# GENERAL ELECTRIC

SUBJECT: SUMMARY OF AUGUST 5, 1980 NRC/GE MEETING ON CORE SPRAY  
DESIGN METHODOLOGY

BWR CORE SPRAY DESIGN

BWR/6 DESIGN METHOD PREDICTIONS OF SSTF

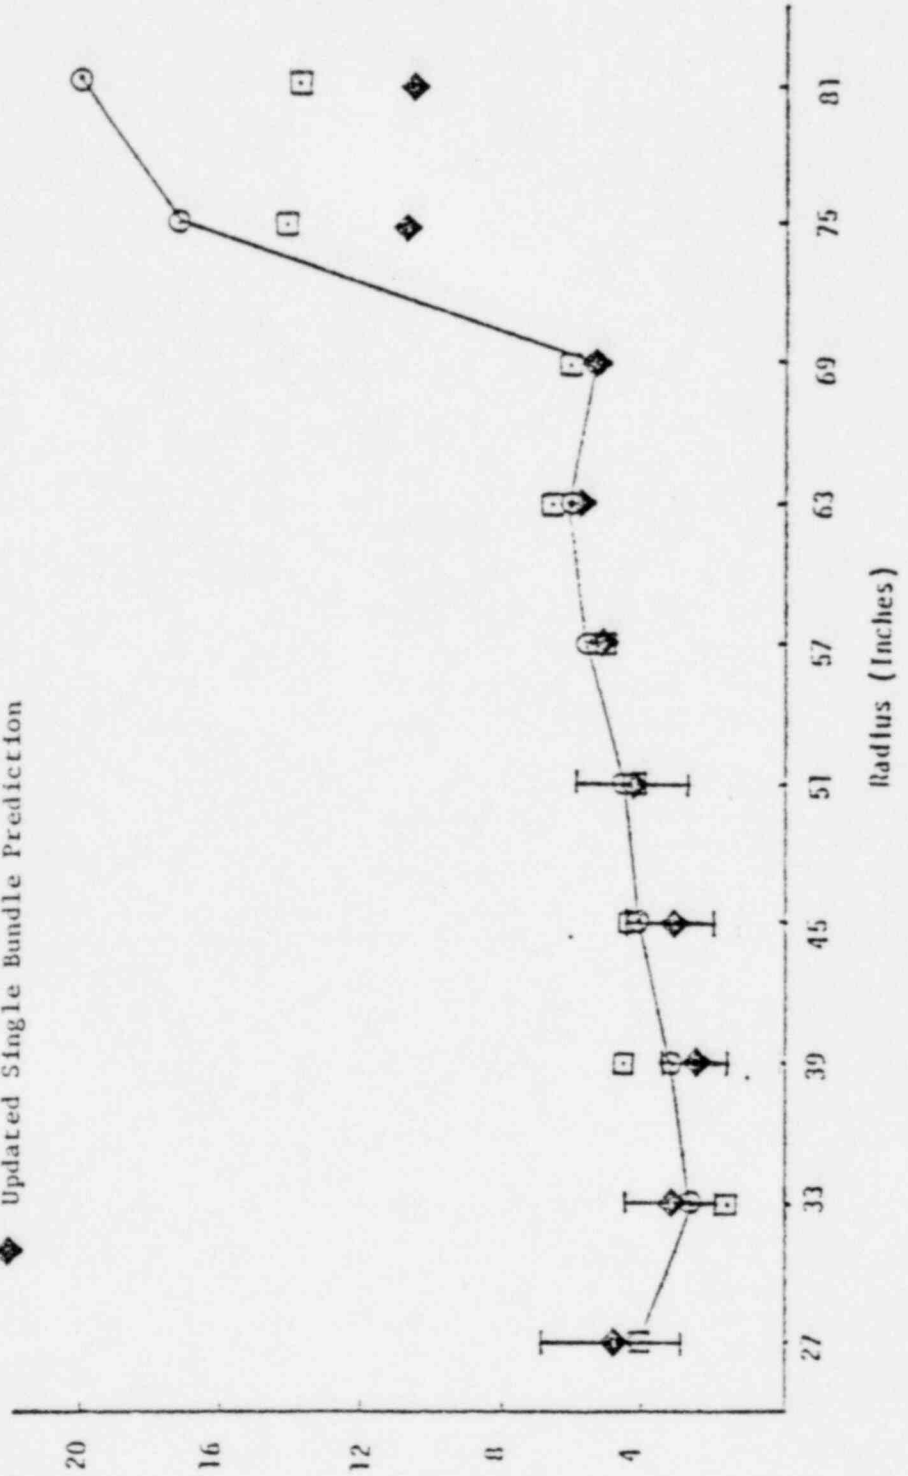
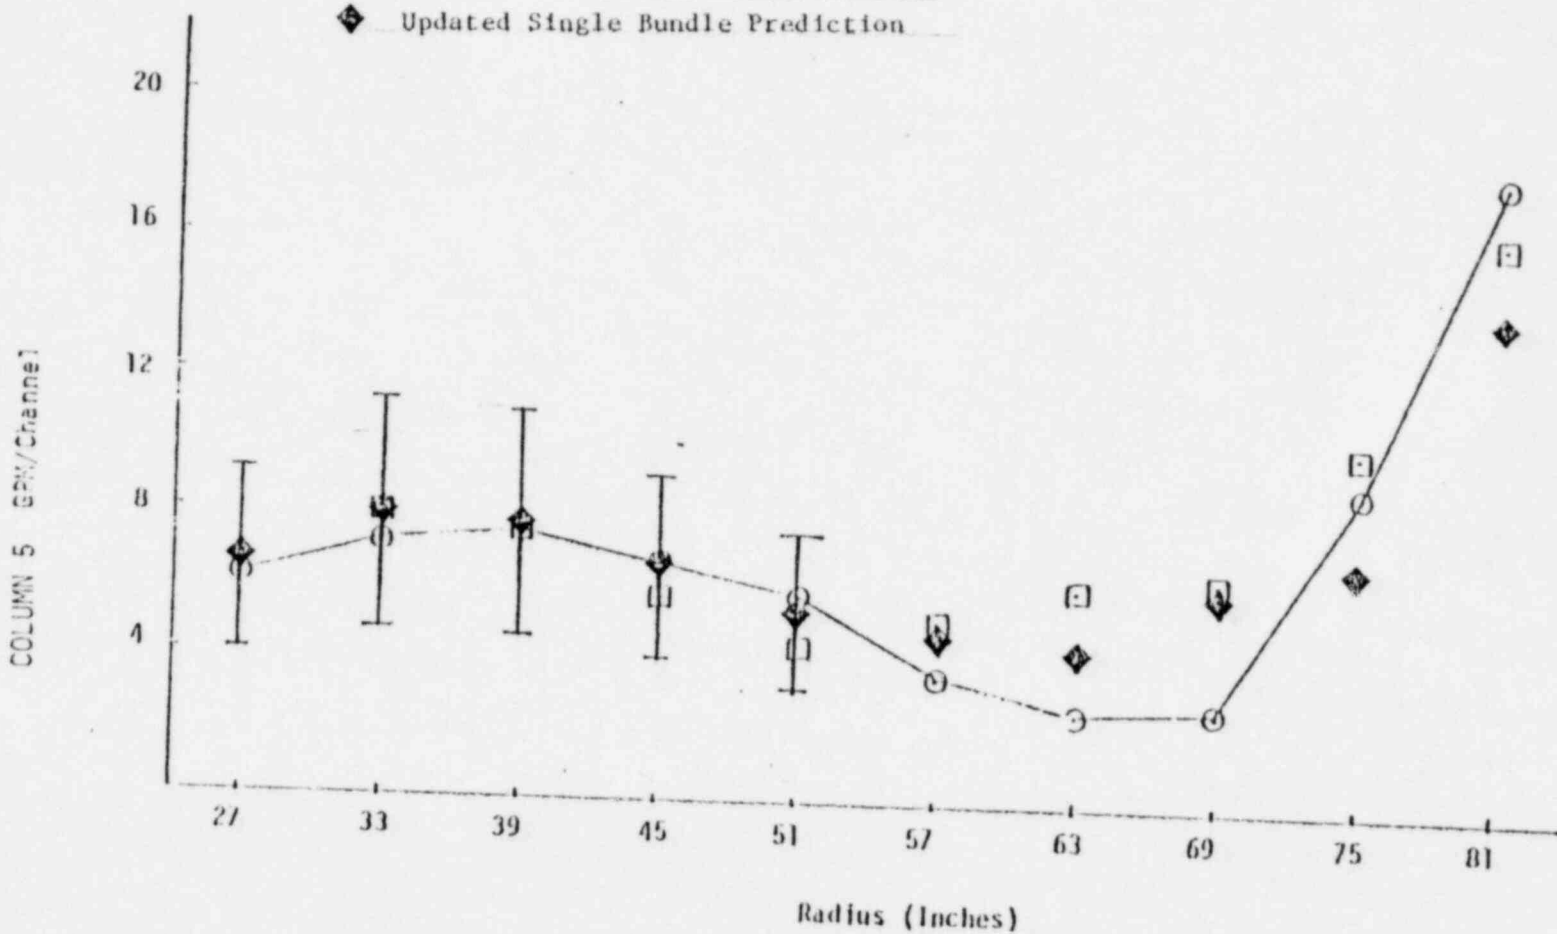
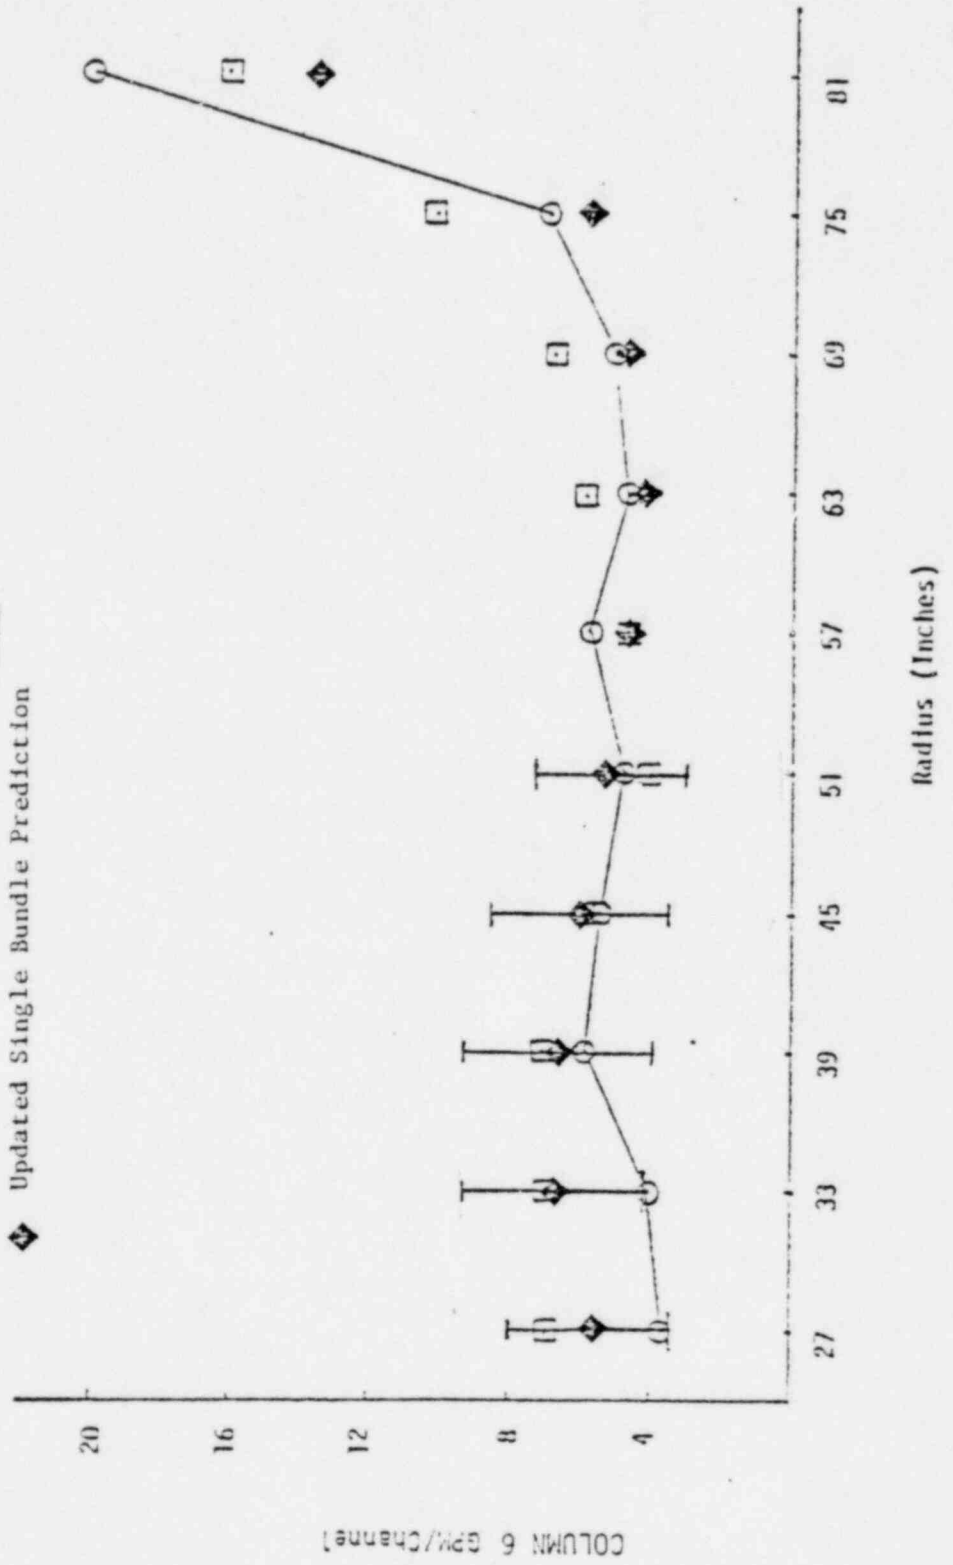
LYNN PRETEST PREDICTION UNCERTAINTY BANDS SEEM TO BE TOO LARGE. THEY SHOULD BE REDUCED BASED ON EXPERIENCE GAINED SINCE PRETEST PREDICTIONS WERE MADE.

THE COLLECTION OF A LARGE SINGLE NOZZLE STEAM DISTRIBUTION DATA BASE SINCE THE PRETEST PREDICTIONS WERE PERFORMED (ASSOCIATED WITH THE BWR/6 SYSTEM DESIGN), NOW ALLOWS FOR SIGNIFICANTLY IMPROVED PREDICTIONS AND MUCH SMALLER UNCERTAINTY BANDS.

- o BWR/6 DESIGN DATA BASE REDUCES UNCERTAINTIES
  - EXTENDED SINGLE NOZZLE STEAM DATA BASE

- o BWR/6 DESIGN VALUES IMPROVE SSTF PREDICTIONS
  - SINGLE NOZZLE MODEL "BEST-FITS" DATA BASE
